No. 90-17

## A. REPLACEMENT OF GIMBAL HOUSING STUDS JUST BELOW THE INNER TRANSOM PLATE ENGINE SUPPORTS ON ALPHA ONE GENERATION II TRANSOM ASSEMBLY

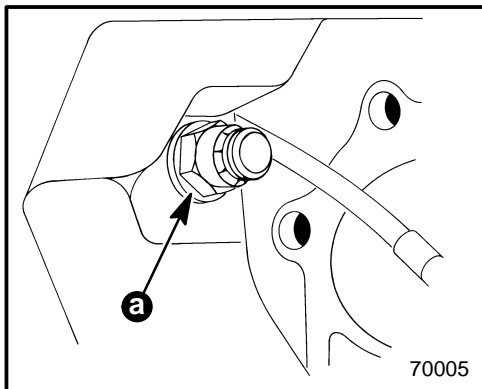
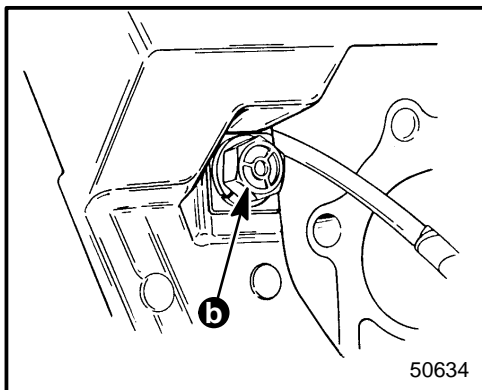
The studs just below the inner transom plate engine supports are too long and may rub on the lower exhaust pipe causing it to wear through.

Replace studs-washers and elastic stop nuts (a) with bolts-lockwashers and square flat washers (b) as shown, and torque to 20-25 lb. ft. (27-34 N.m).

a - Locknuts and Flat Washers

b - 4-1/4 in. (108mm) Long Bolts Lockwashers and Square Flat Washers (2)
